SERVICE BULLETIN

SERVICE BULLETIN NO: 28-009

ENGINE FUEL AND CONTROL - DISTRIBUTION ENGINE-DRIVEN FUEL PUMP - TORQUE CHECK OF RELIEF-VALVE-BODY SCREWS

Torque Check and Fuel Leak Inspection of the EDP
Figure 1

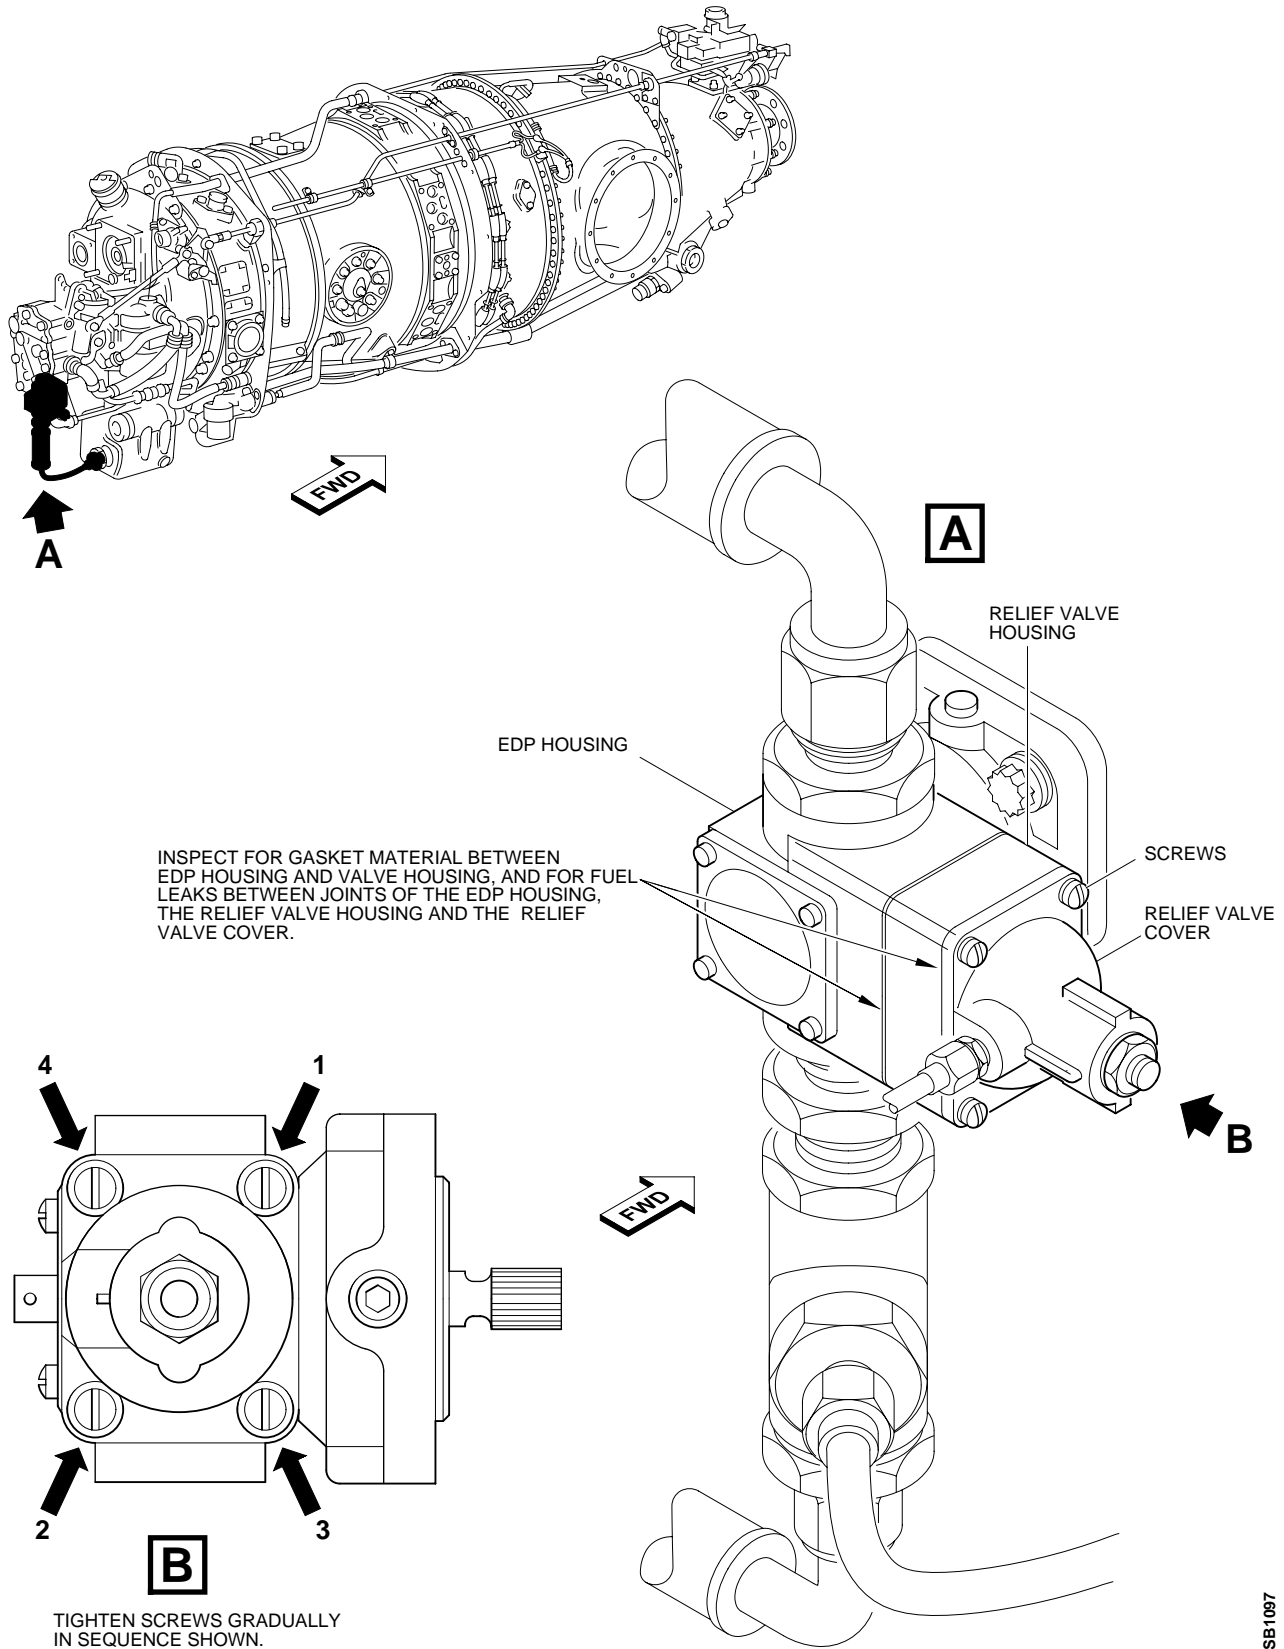
B. Inspection and Torque Check of the EDP Relief Valve (Ref. Fig. 1)

- (1) Do an inspection of the joints between the EDP housing, relief valve housing and the relief valve cover for:

- Fuel leakage
- Gasket material pushed out

- (3) Use a torque screwdriver to do a check of the torque value of the relief-valve-cover screws. Do the check clockwise only. The minimum torque value must be 23 lbf in. (2,6 Nm).

- (a) Cut, remove and discard the lockwire that safeties the relief-valve-cover screws.
- (b) Torque the screws gradually to between 23 and 25 lbf in. (2,6 and 2,83 Nm). Do this in the sequence shown in Figure 1, Detail B.
